Subject: Byron Ultimate Heat Sink
 Byron Units 1 and 2,
 NRC Docket Numbers 50-454 and 50-455

Byron/Braidwood UFSAR Change Log

Byron/Braidwood
 UFSAR Change Log
 DRP 4-009

FIGURE 9.2-11

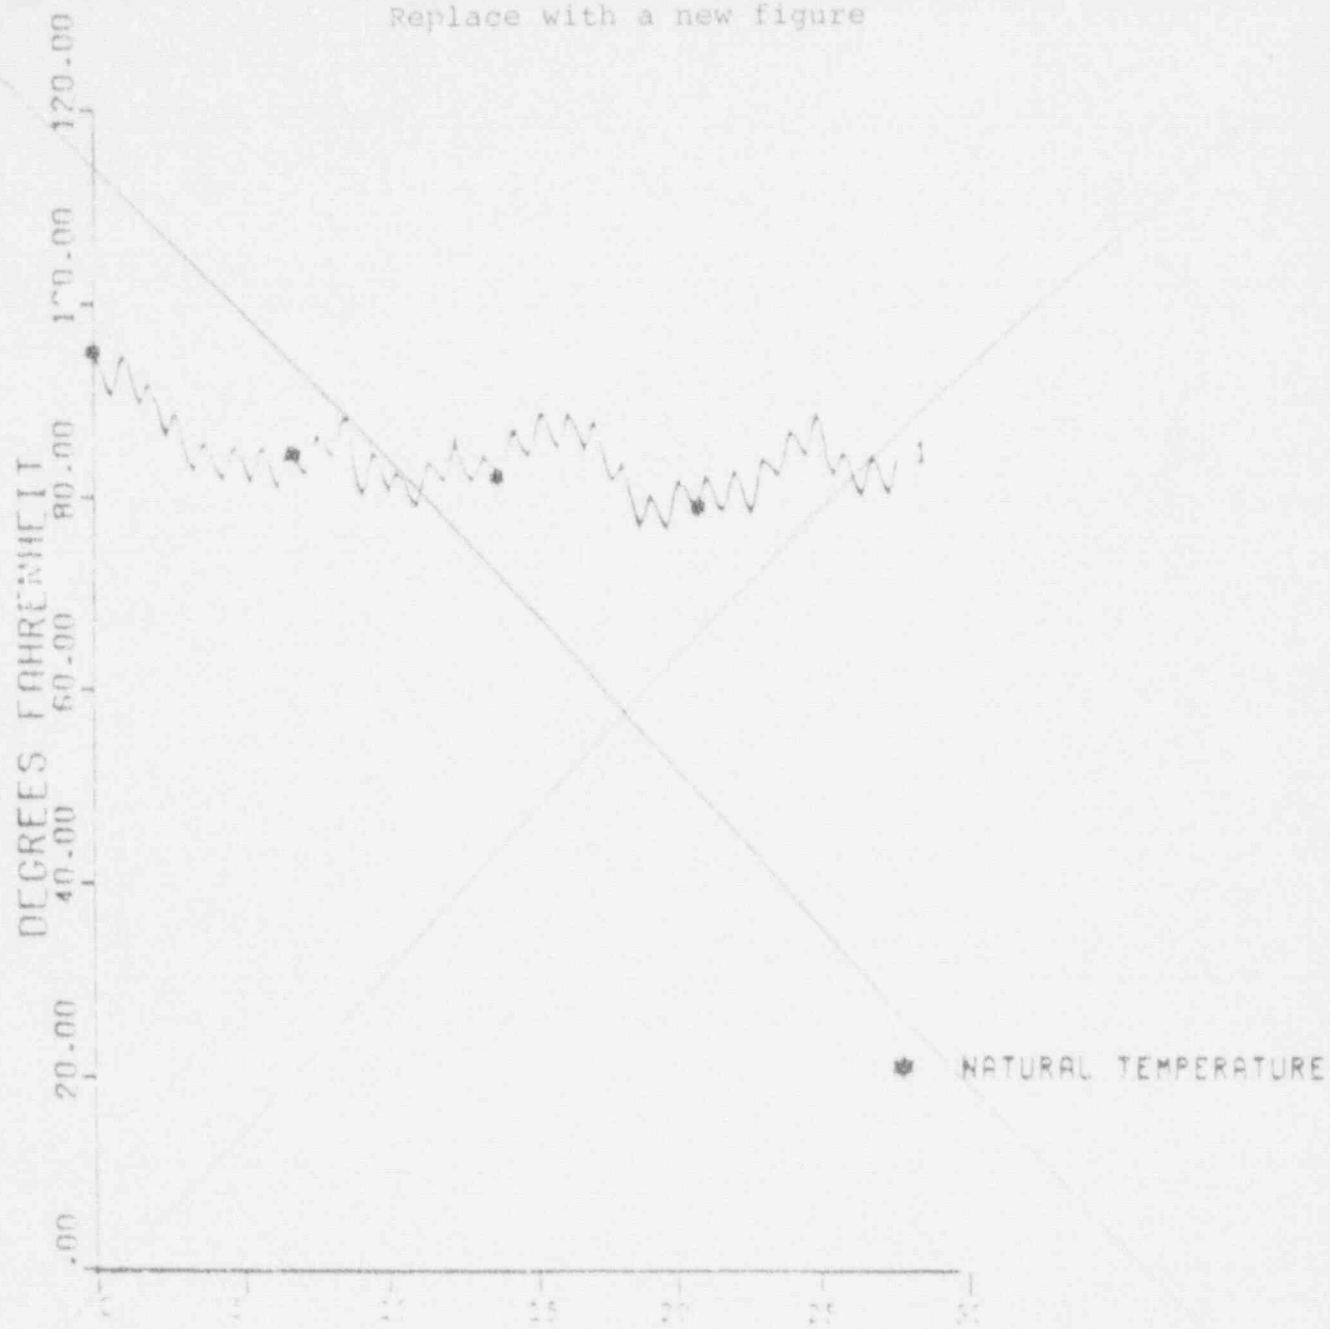
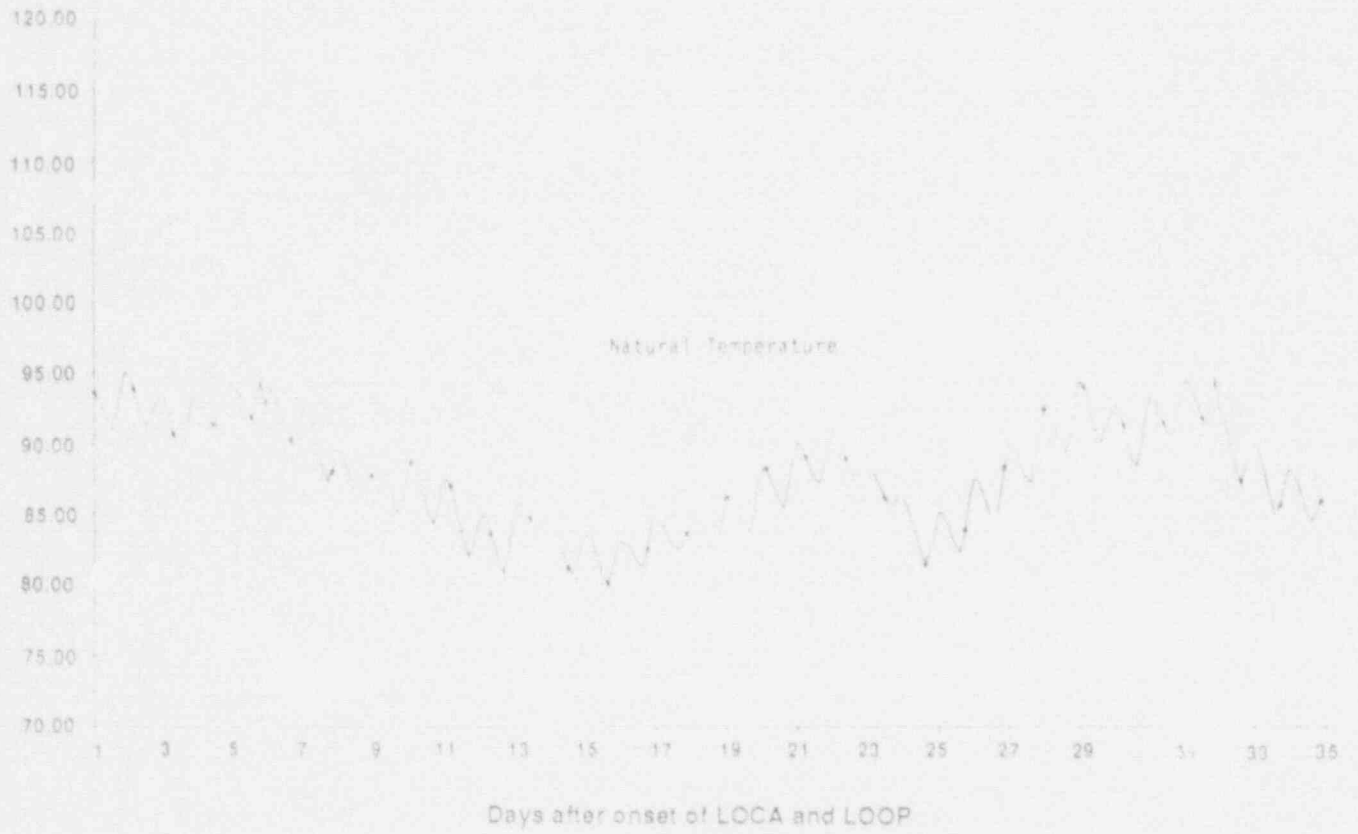
9.0	9.0-xvi	Denote Figures 9.2-9 through 9.2-14 as applying to Braidwood only, add Figures 9.2-30 and 9.2-31	Editorial	Changes are per this DRP
9.2.1.2.1	9.2-2	Revise section	Reflect design basis	IHS Final Report

Section	Page	Description of Change	Reason/Basis	References/Remarks
9.2	F9.2-7	Revise Figure 9.2-7	Document calculation results	Calculation ATD-0063, Revision 1, dated April 1, 1992
9.2	F9.2-8 to F9.2-14	Change Figures 9.2-8 through 9.2-14 to 'Braidwood Only'	Editorial	Byron does not have a cooling pond
9.2	F9.2-9 to F9.2-14	Replace Figures 9.2-9 through 9.2-14	Document calculation results	"Thermal Performance of the Ultimate Heat Sink During a Loss of Coolant Accident," S&L Calculation ATD-0109, Revision 1, April 27, 1992
9.2	F9.2-30	Add Figure 9.2-30	Document calculation results	Calculation RSA-B-91-03, Figure 14
9.2	F9.2-31	Add Figure 9.2-31	Document calculation results	Calculation RSA-B-91-03, Figure 15

Replace with a new figure

FIGURE 9.2-12

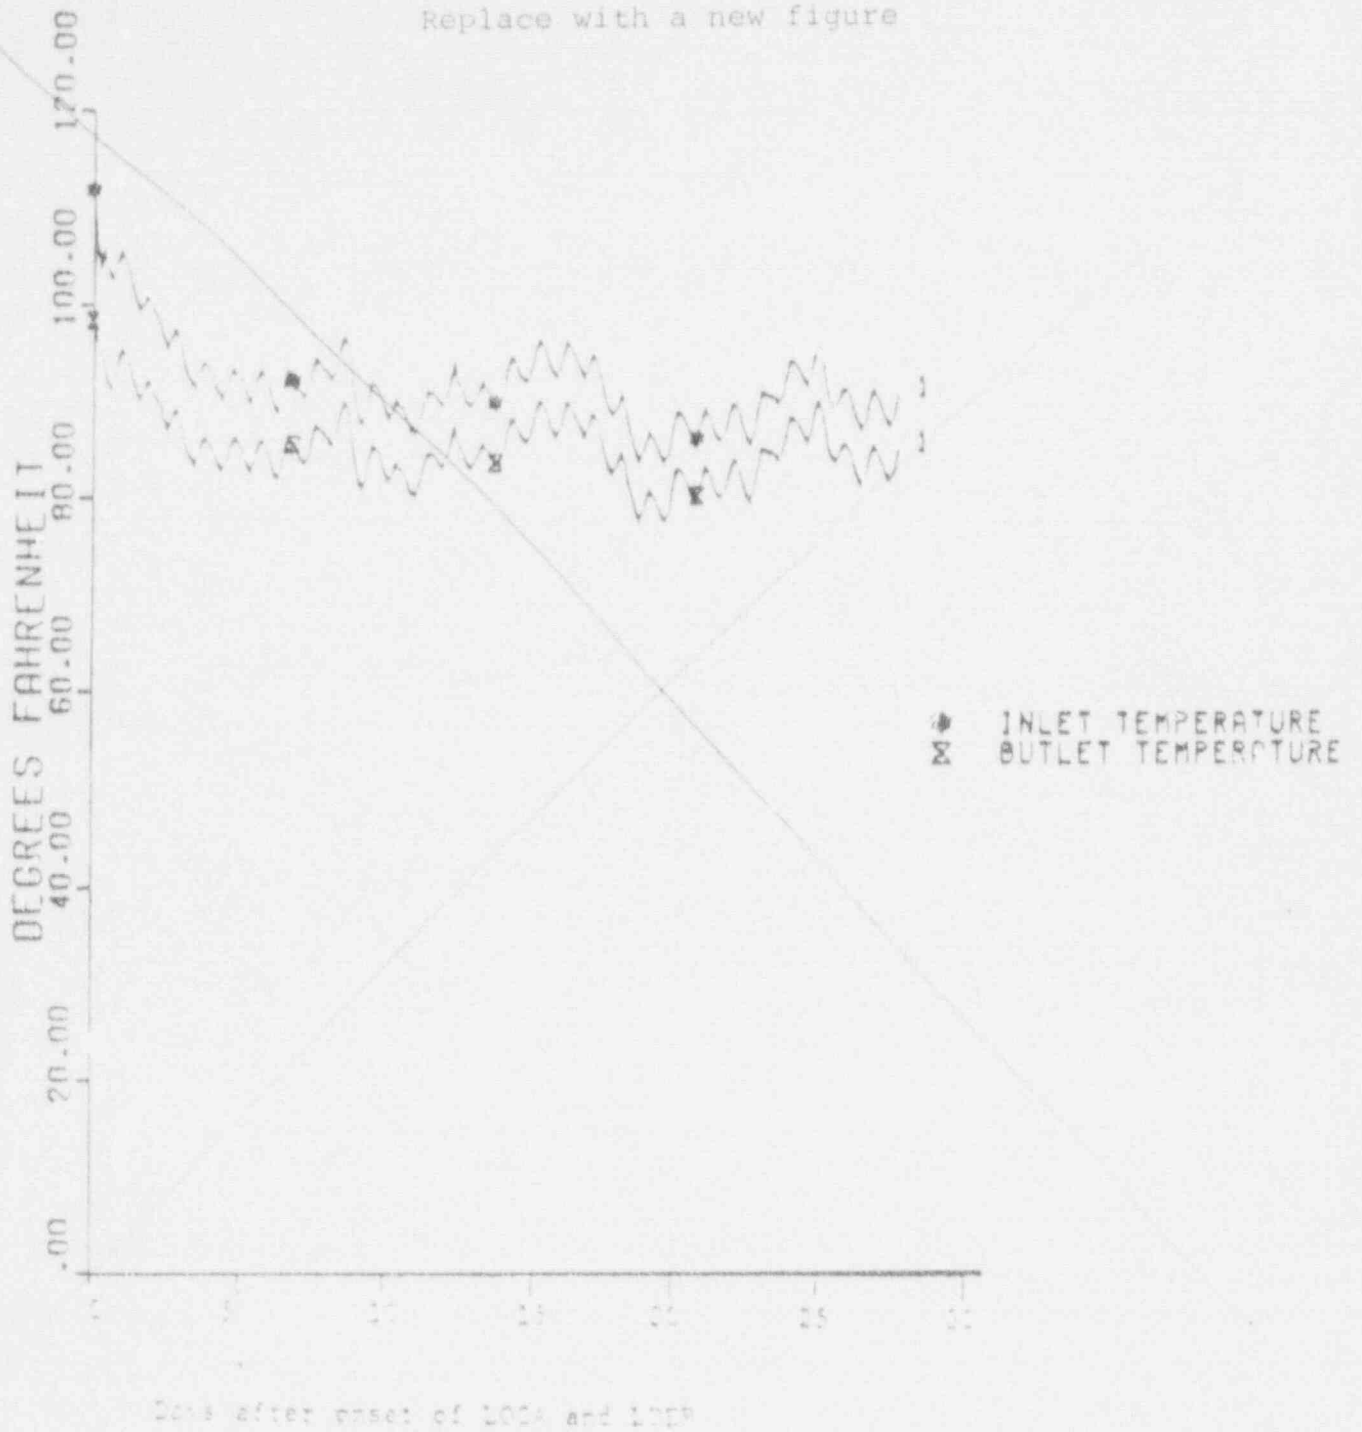
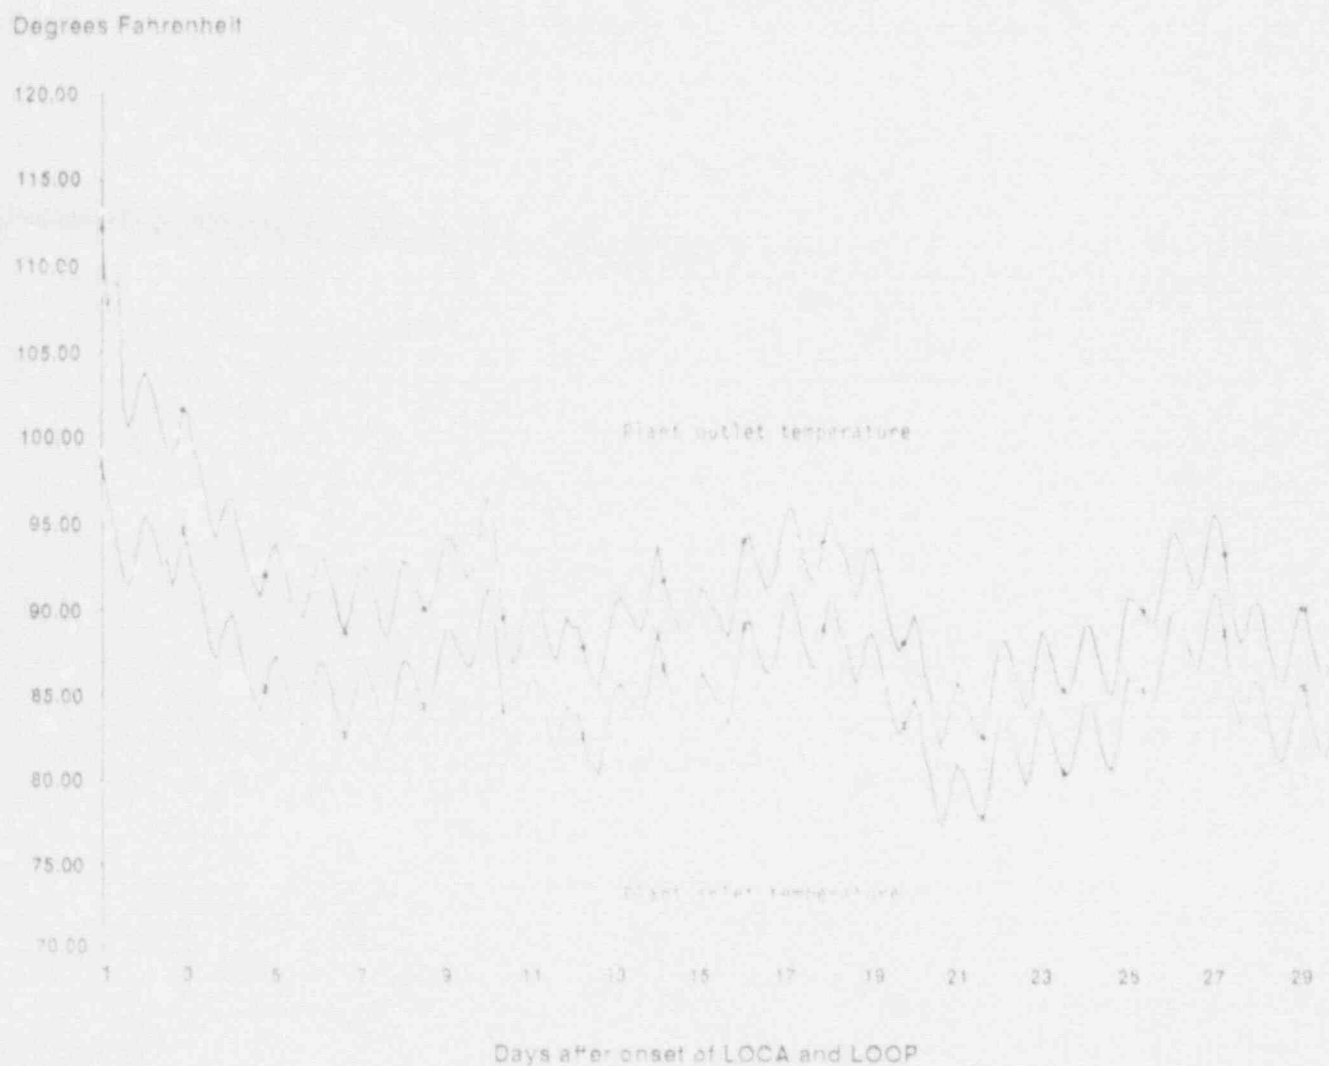
Replace with a new figure

FIGURE 9-2-13

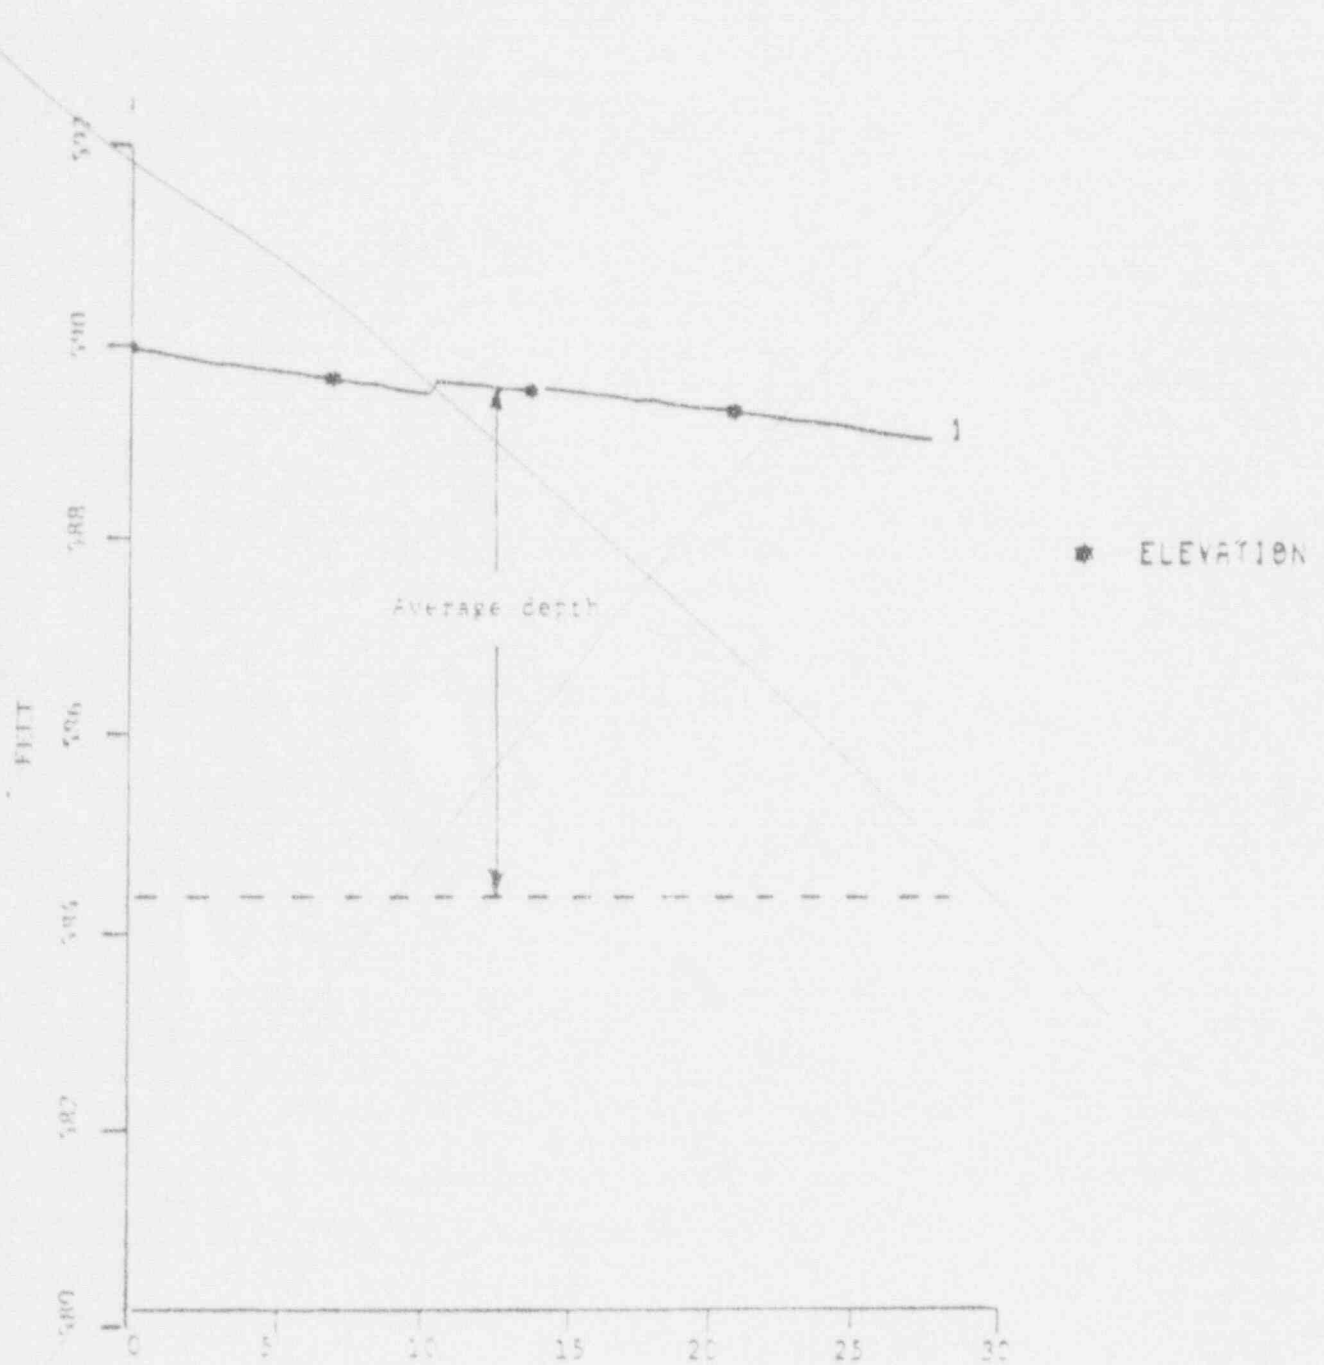
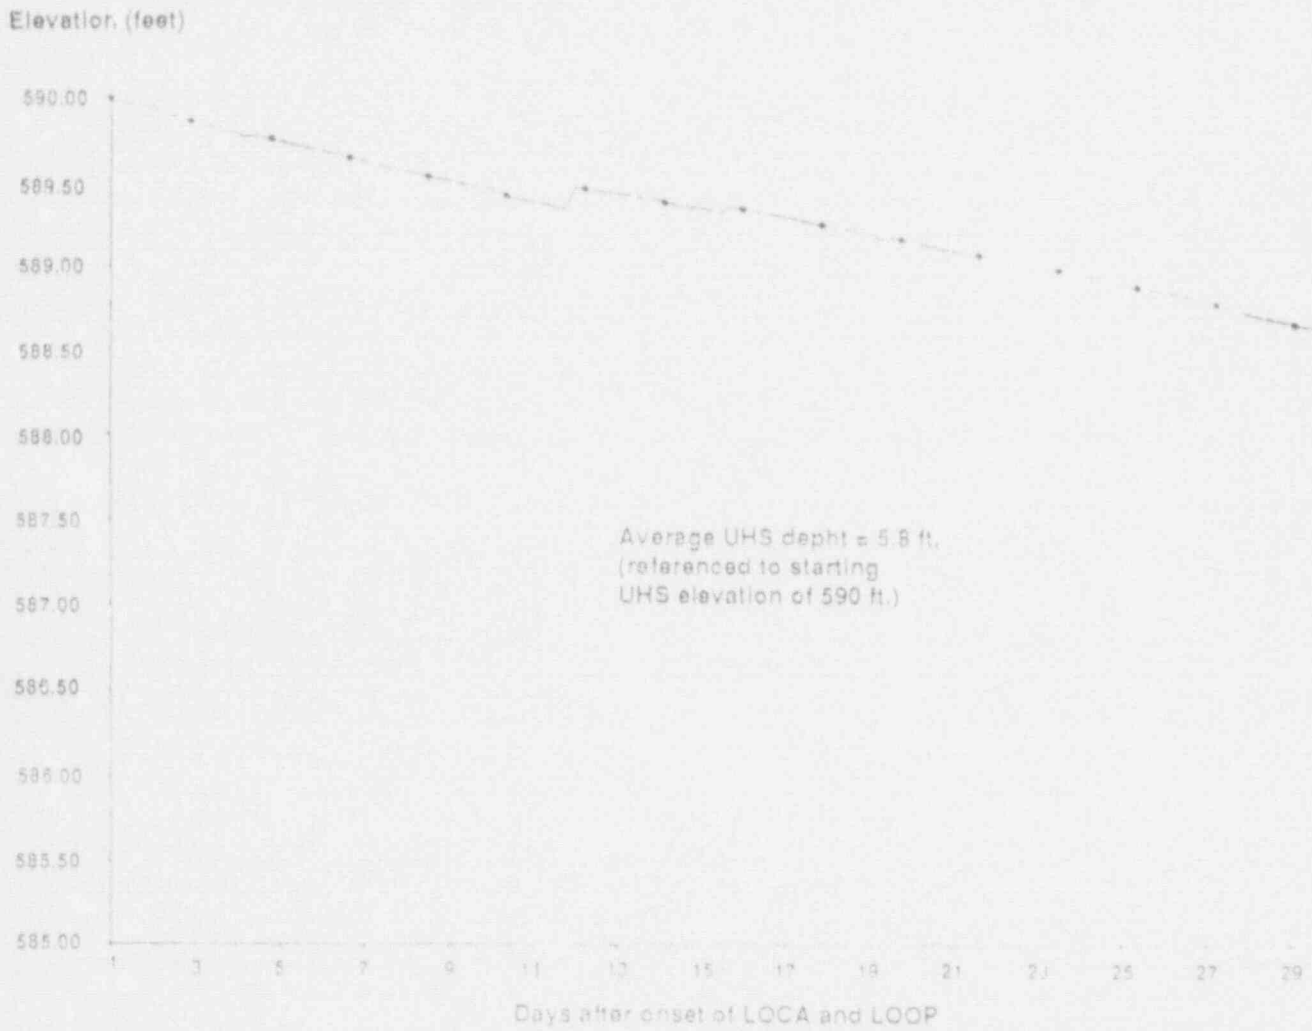
Replace with a new figure
